141-143 CUMBERLAND AVENUE

AP 141 Cumberland Ave.—Change of two-family dwelling house
to three apartments with physical alterations

AP 141 Cumberland Ave.—Application for permit to partition off bathroom on third floor and question if the the building is not being used unlawfully under the Building Code

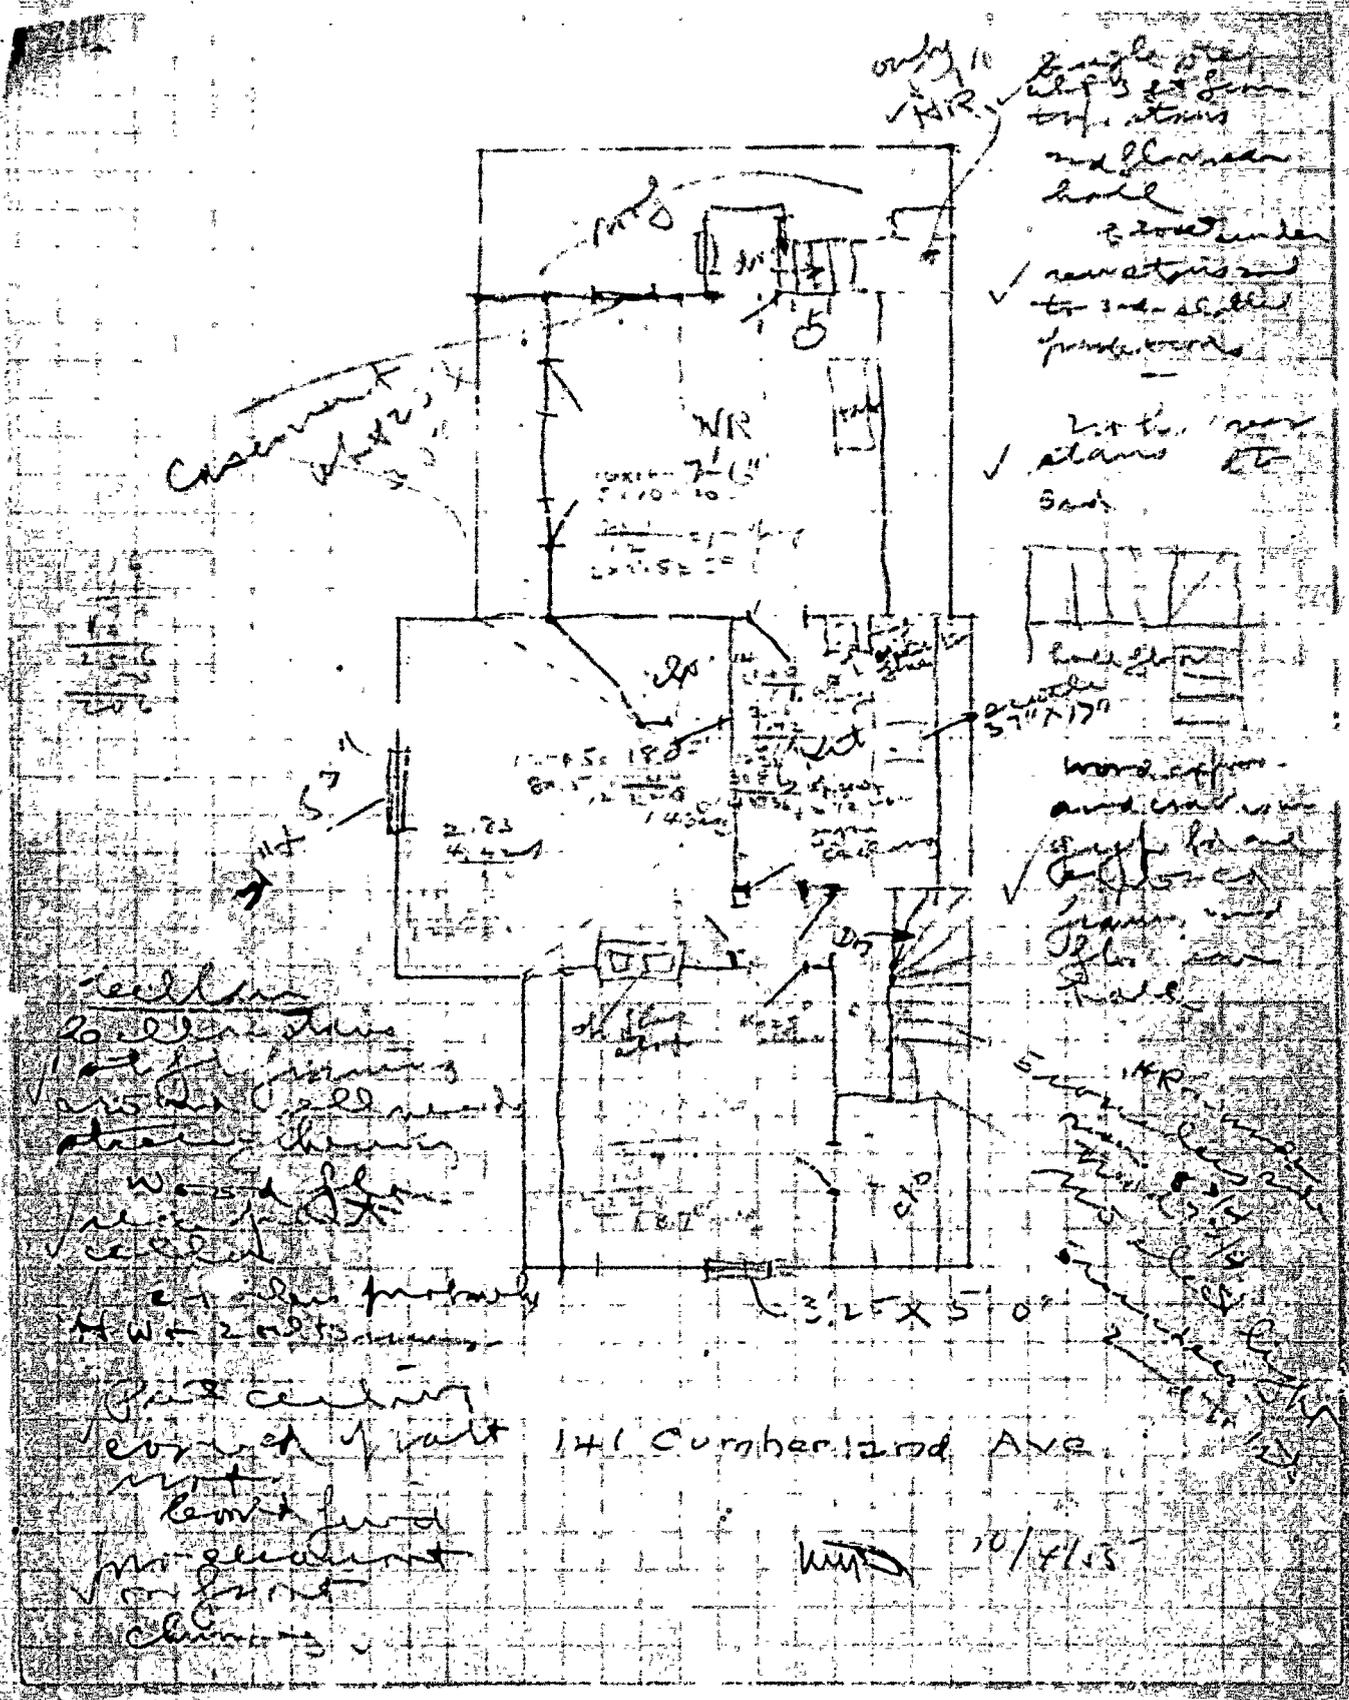
Continue as hold.
Owner in today
and he is to find
out if he can do
FRS 3, 4, 5, 9, 10, 11,
12. If he can
he is to let us
know that he can,
we are to see if
Fire Chief can
with go near
stairs (to 8) and if
so, certify appeal
in FRS 1, 2, 6 + 7

Sect 203
 OK a 2 apt - one on each
 OK b
 OK c
 dtg. Front room 12 ft.
 2 of side room
 14 ft do kitchen
 60 sq ft def - main room 70 sq ft
 7 ft bar over all
 part of kitchen
 + what rest!

2.1.10) Provide way
 for occupants of
 front and gl room
 to get through side
 door to rear
 room or kitchen
 - through W side stairs

2. 2 1/4 full
 length all
 stairs except
 cellar

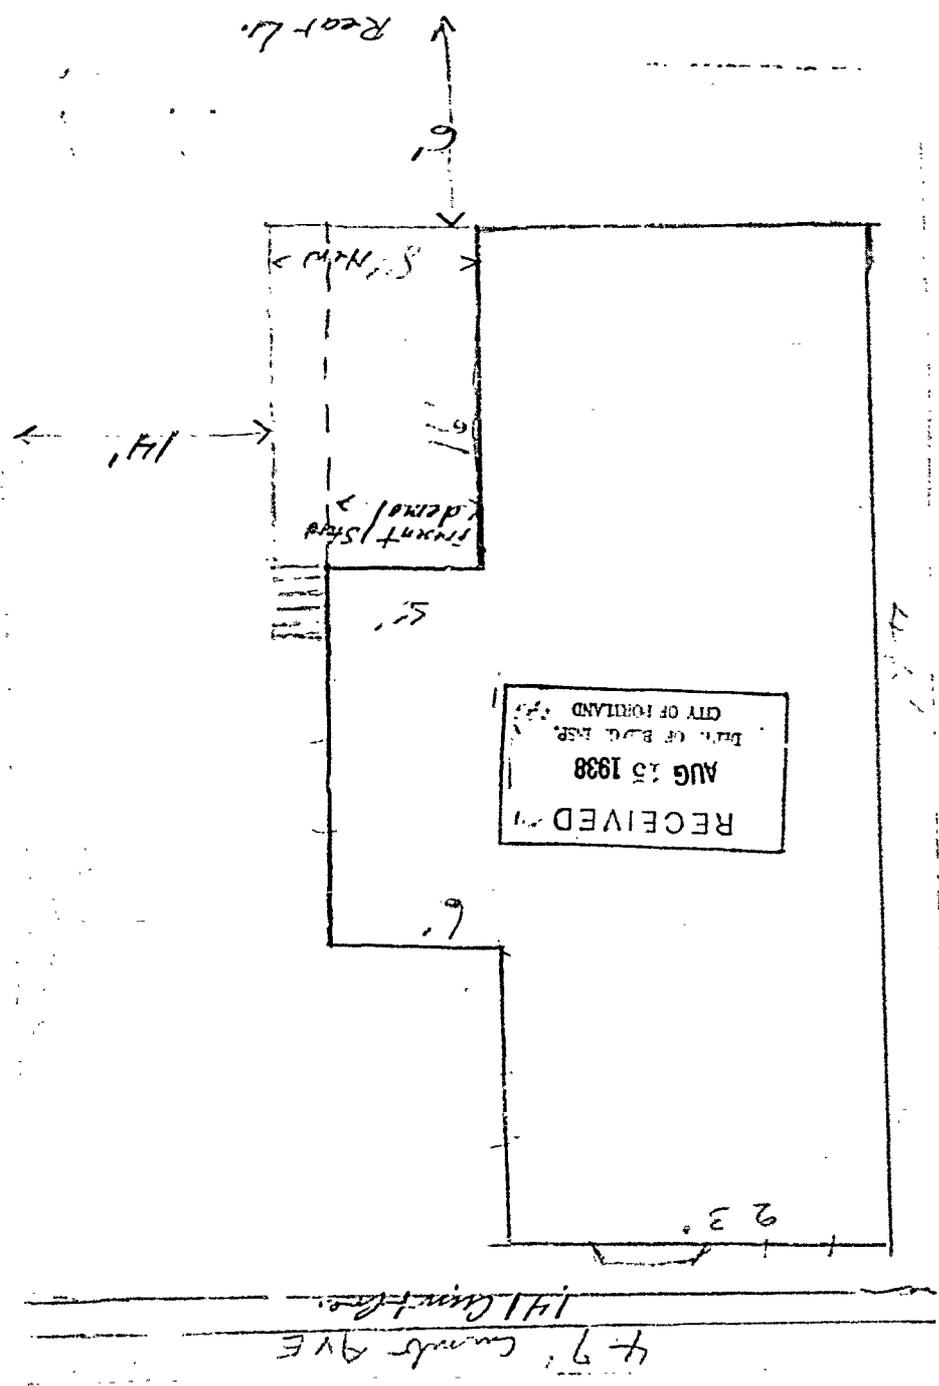
The framing plan shown is presumably for the first floor only.

Please give us the answer to the above questions and correct the size of the 4x6 girder through the center, and give us a framing plan of the second floor.

Please note that if the owner plans to put a roof on later, 4x6 posts should be used now. If he plans a roof later, it is advisable to use concrete piers for a foundation now, as when he applies for the permit to put the roof on later, it will then be necessary to change the cedar posts out to concrete piers to comply with the Building Code.

Are you sure of the six foot dimension to the rear line? If this is correct it is doubtful if I may issue the permit as you are enlarging the size of the present piazza and the usual required distance to the rear line is eight feet in such a case. It is possible that this deficiency in distance may be overcome by appeal to the Municipal Officers. If this six foot distance is correct, I shall be glad to explain the appeal rights to the owner if he will come to this office at sometime between the hours of one o'clock and three o'clock some day other than Saturday.
